MINERALS PROGRAM INSPECTION REPORT
PHONE: (303) 866-3567

MINE NAME: Whitewater Pit 500	MINE/PROSPECTING ID#: M-1977-129	MINERAL: Sand and gravel	COUNTY: Mesa
INSPECTION TYPE: Monitoring	WEATHER: Clear	INSP. DATE: May 9, 2023	INSP. TIME: 10:00
OPERATOR: Whitewater Building Materials Corporation	OPERATOR REPRESENTATIVE: Mark Gardner	TYPE OF OPERATION: 112c - Construction Regular Operation	
REASON FOR INSPECTION: Normal I&E Program	BOND CALCULATION TYPE: Complete Bond	BOND AMOUNT: \$287,500.00	
DATE OF COMPLAINT: NA	POST INSP. CONTACTS: None	JOINT INSP. AGENCY: None	
INSPECTOR(S): Amy Yeldell	INSPECTOR'S SIGNATURE: 	SIGNATURE DATE: May 25, 2023

Photo Sixteen: Southern mine, infestations of knapweed and
other weeds choking out desirable vegetation

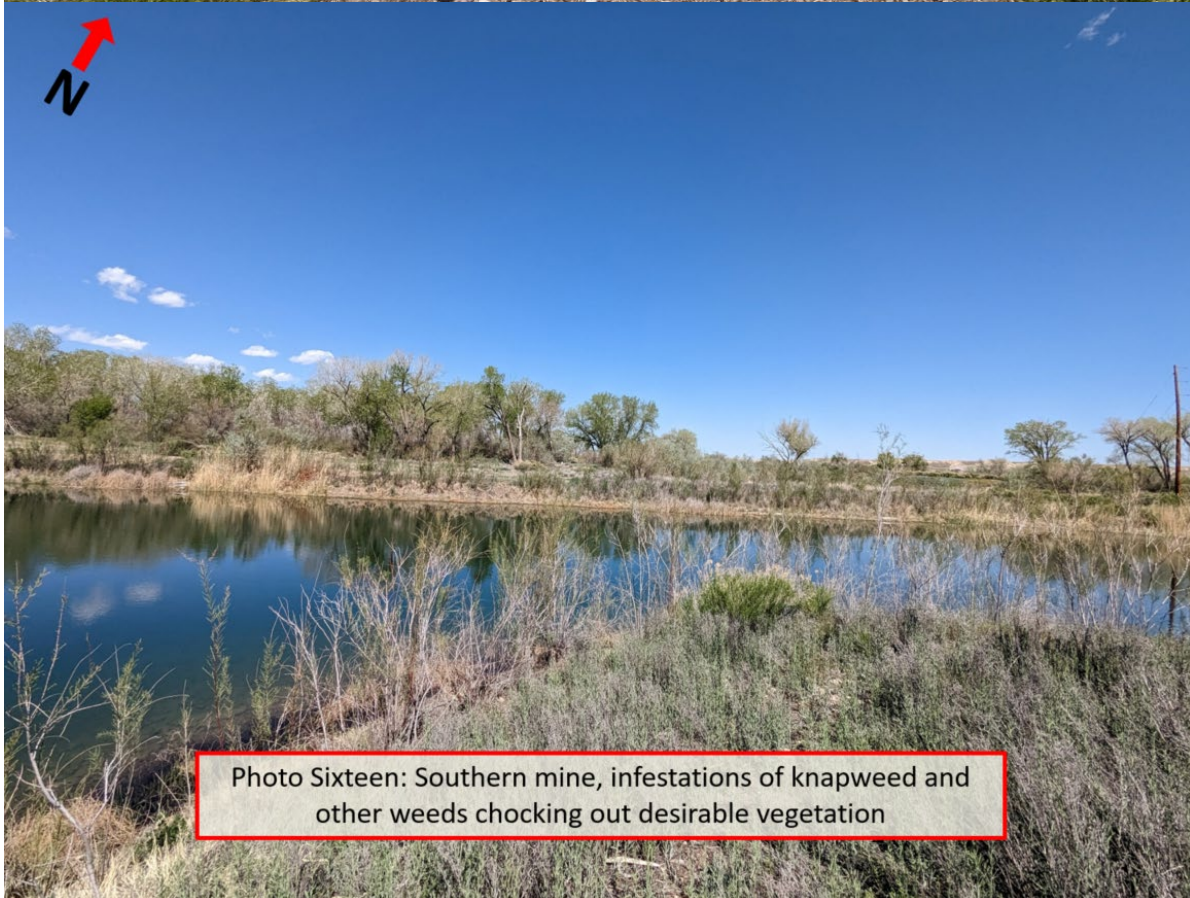
Within Phase Z, 2W, 2E, and W, portions of the lakes are revegetated, however desirable vegetation is inadequate. Noxious weeds have degraded reclaimed areas. Void or sparse areas could benefit from additional touch up seeding (Photo Sixteen). If areas void of vegetation or sparse in desirable species do not germinate in the next few weeks additional seeding efforts are recommended.

An infestation of knapweed was observed on the southeast finger of the pond in Phase 2W (Photo Seventeen). Noxious weeds in the southern areas need to be more aggressively managed. Site wide the Operator needs to be

diligent in treating of weeds to avoid building up a seed bank on site. Treatment of noxious weeds includes the management and removal of Tamarisk and Russian Olive for those areas reclaimed after 2005. While a Noxious Weed Management Plan was incorporated under TR-3 the plan and its implementation are inadequate. Noxious weeds are threatening the continued development of desirable vegetation, this is a problem pursuant to Rule 3.1.10(6). The Operator needs to provide photo documentation that a spring treatment of noxious weed has occurred. Additionally the Noxious Weed Management Plan needs to be revised to reflect current site conditions.
